TO: City Council
FROM: Ben Hetzel, City Planner
REVIEWED BY: Molly Just, Planning Director
ITEM: Carmelite Hermitage of the Blessed Virgin Mary Conditional Use Permit for Chapel

To: Ben Hetzel, City Planner
Cc: Molly Just, Planning Director
Chad Isakson, Assistant City Engineer
From: Jack Griffin, P.E., City Engineer
Re: Carmelite Heritage Chapel Site Improvements
Engineering Site Plan Review

CARMELITE HERMITAGE CHAPEL

CONDITIONAL USE CONSTRUCTION PLAN SET

3.20 OF 13

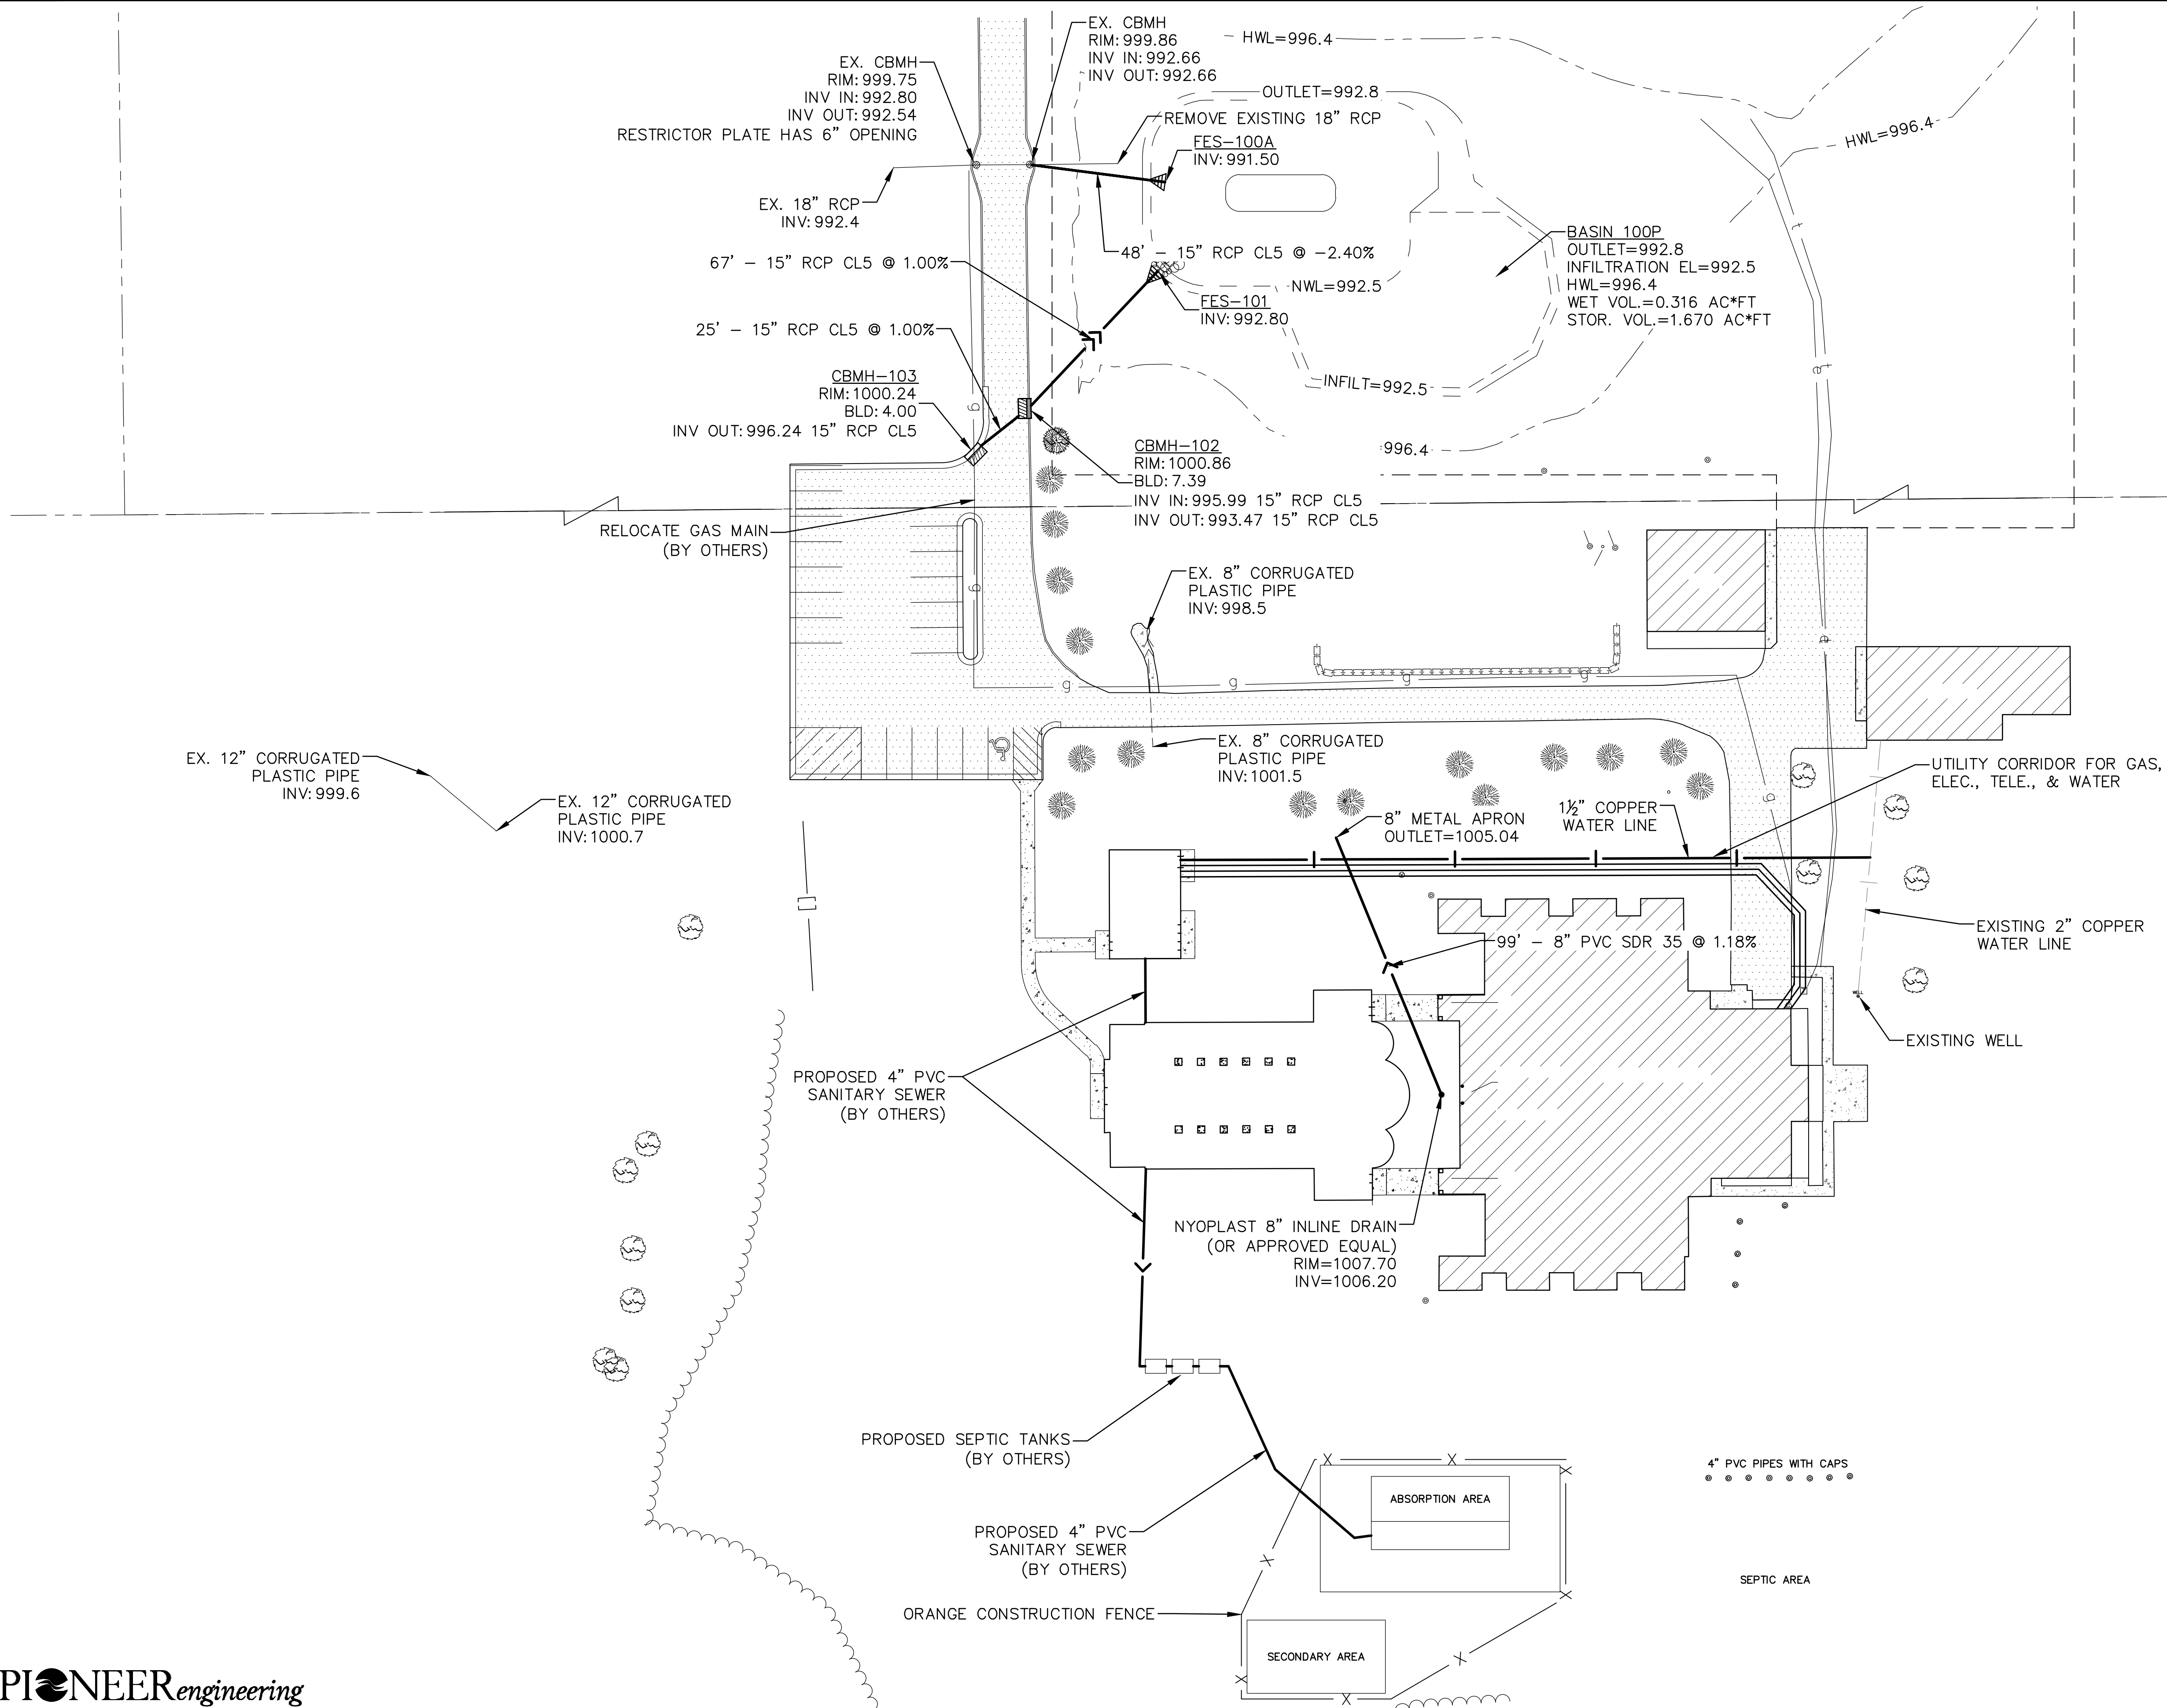
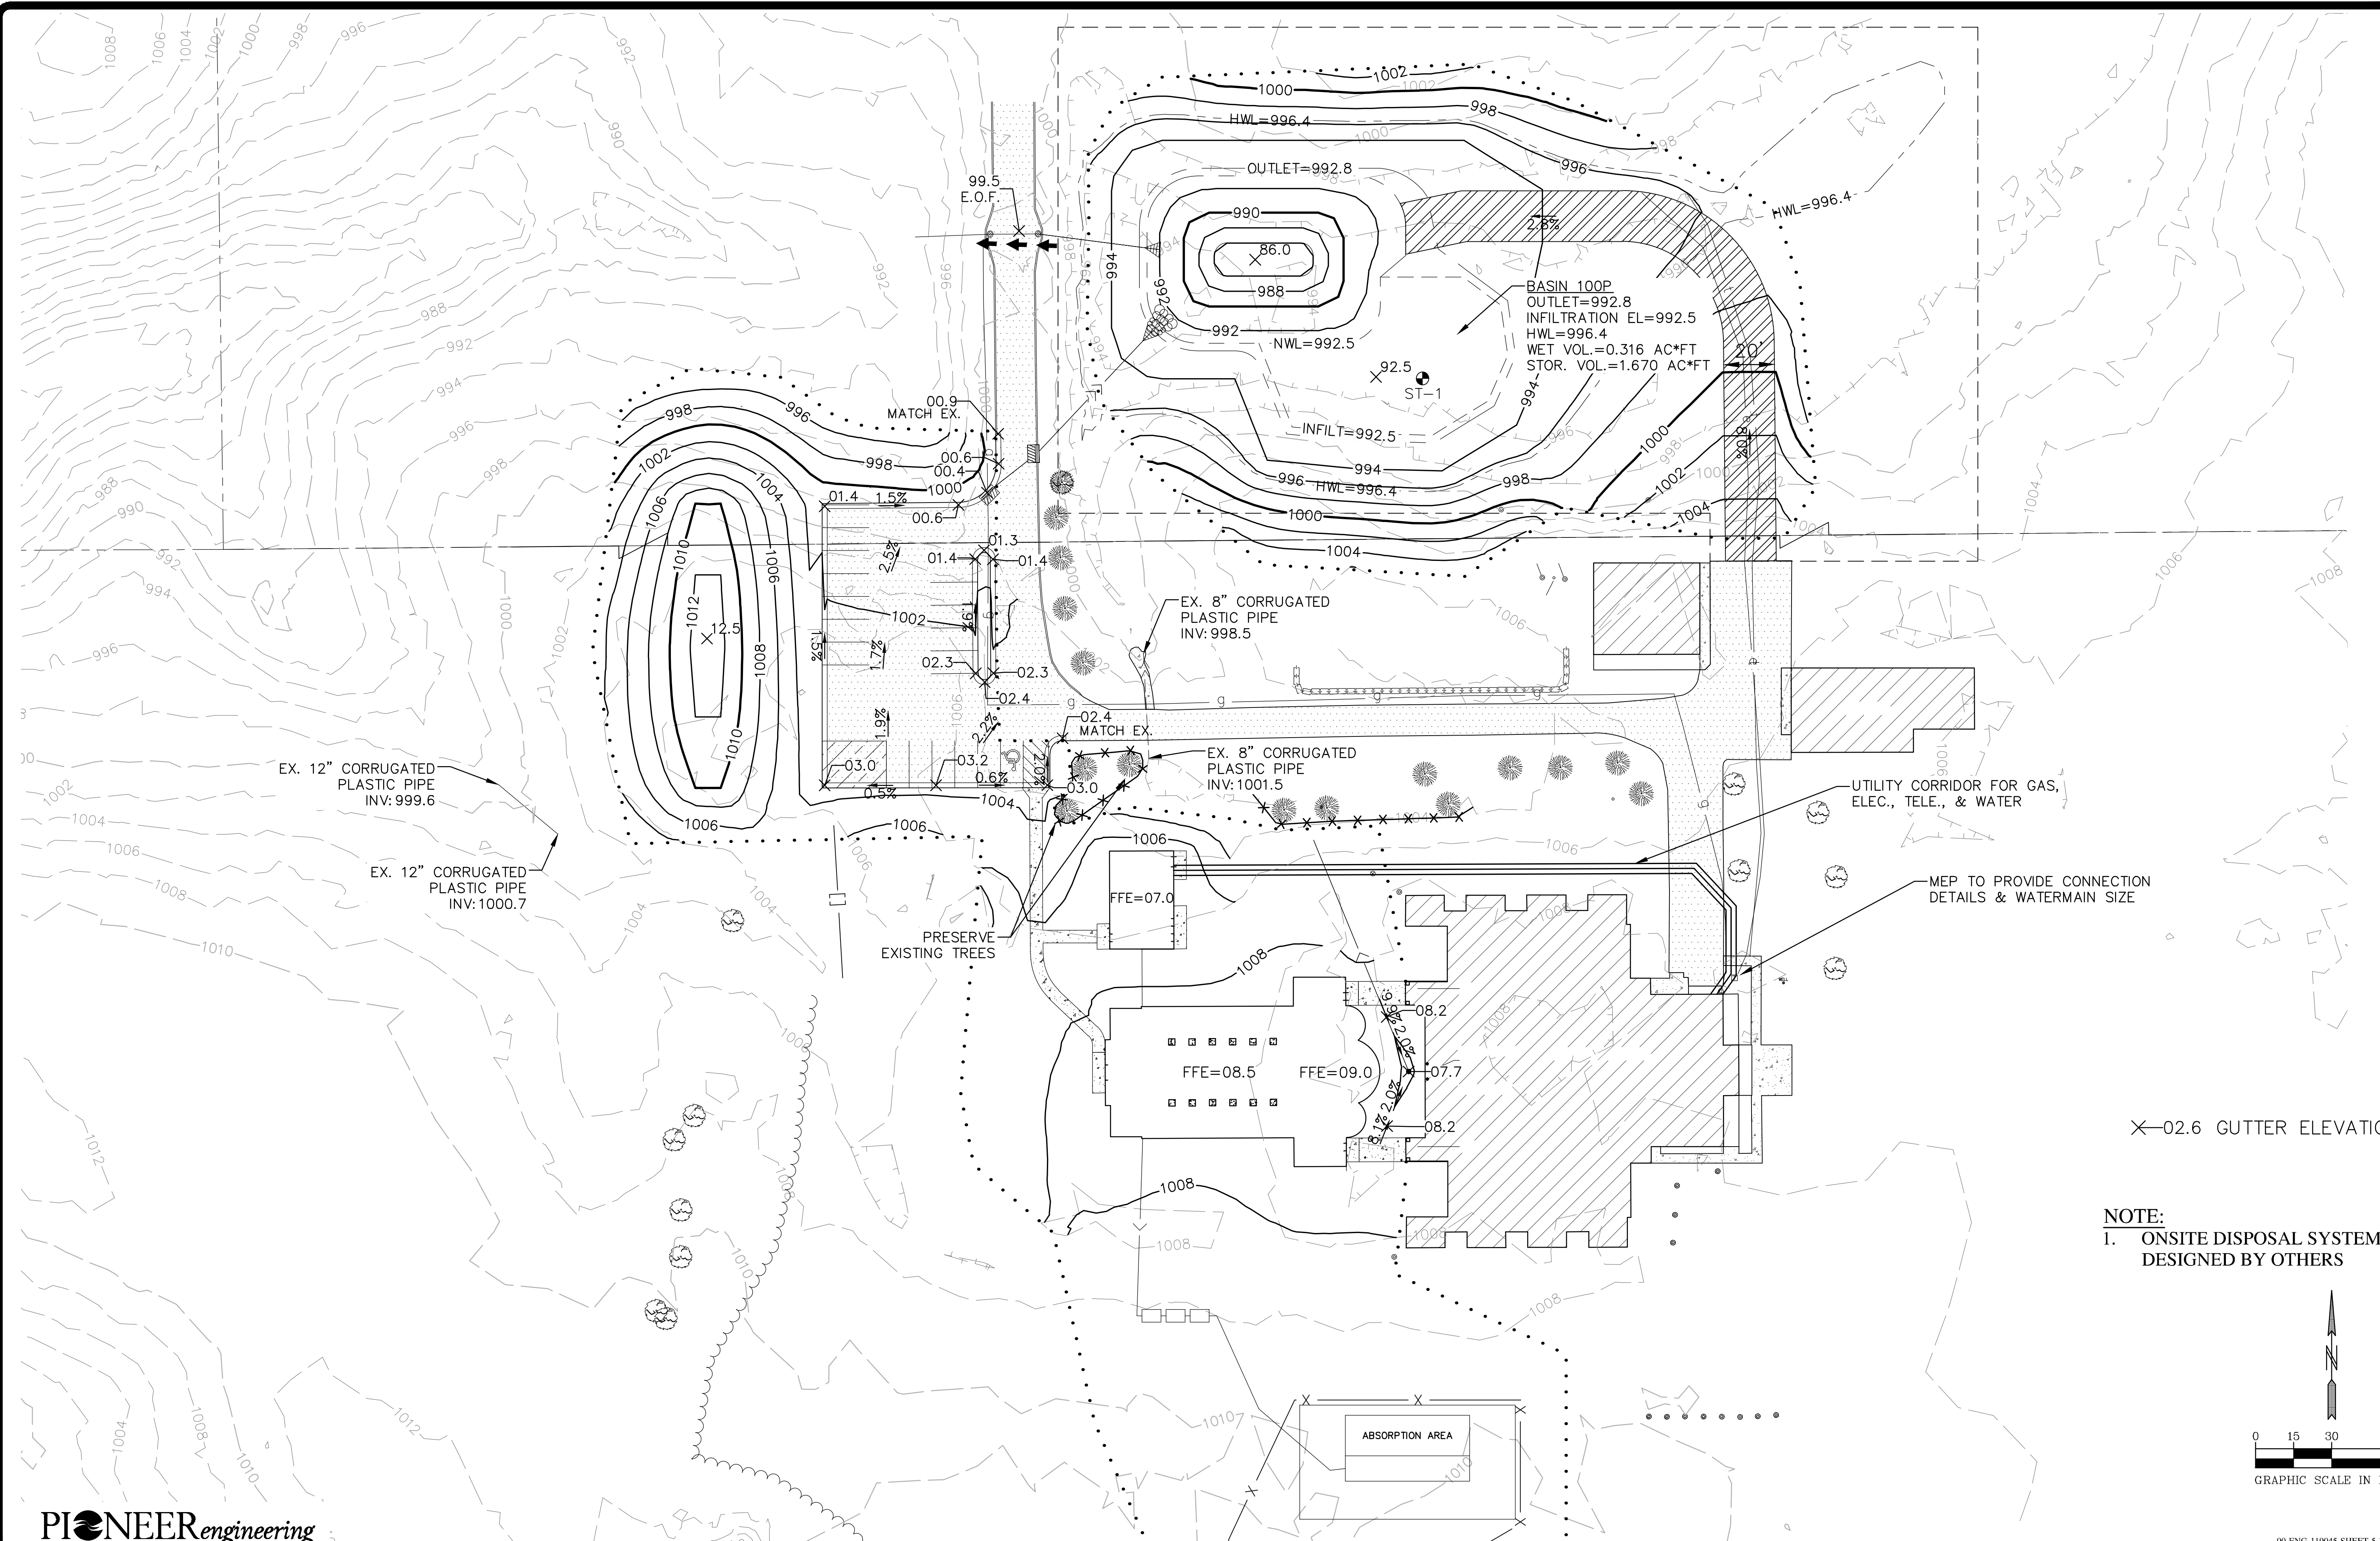
- Sheet 4.10. A plan note should be added to indicate the private sanitary sewer and water service lines to be installed per state plumbing code requirements.

GRADING PLAN

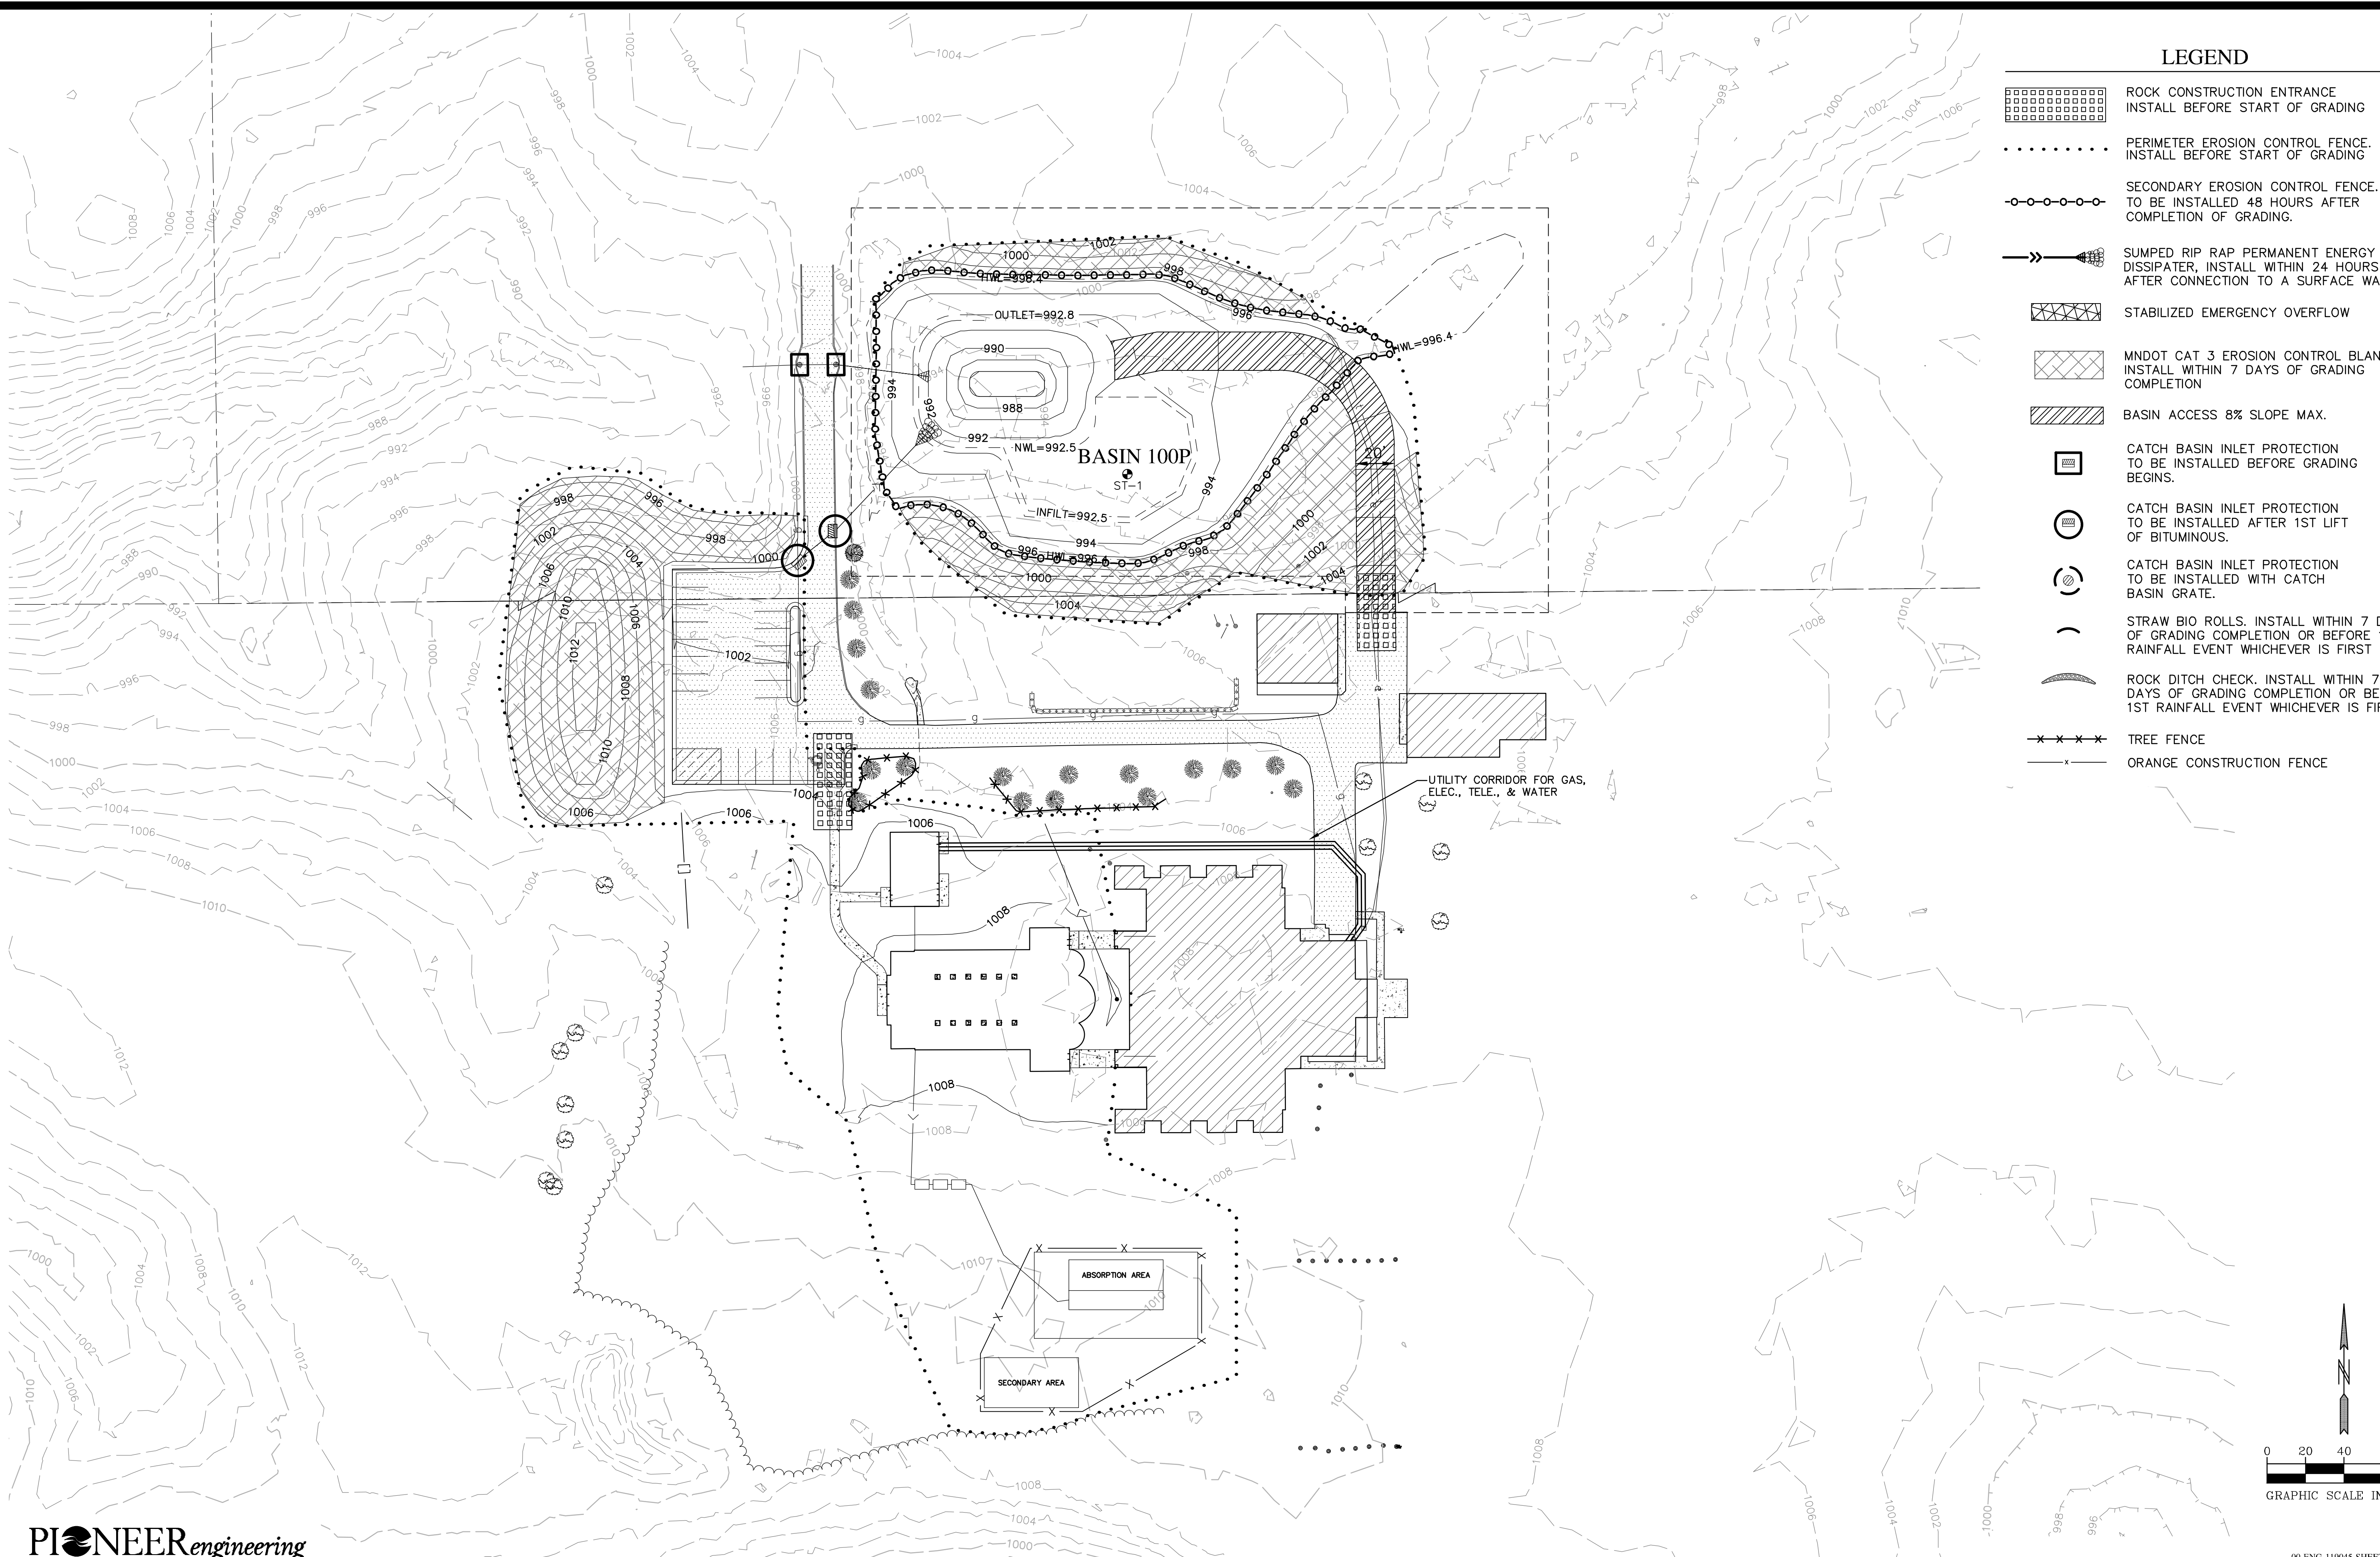
- Sheet 5.10. Revise grading plan to revise storm water BMP site to meet City of Lake Elmo and MN Storm Water Manual standards and as follows:
 - Provide 10:1 aquatic bench and 10:1 maintenance bench around retention BMP. Add typical pond detail cross section to identify required benches.

- Provide defined rip rap overflow location between retention basin and infiltration basin and define overflow spot elevation.
- Sheet 5.10 Provide drainage and utility easement over storm water BMP including the 100-year HWL, emergency EOF pathway, and pond maintenance access road and access bench. Easement area must be clearly shown on the plans.
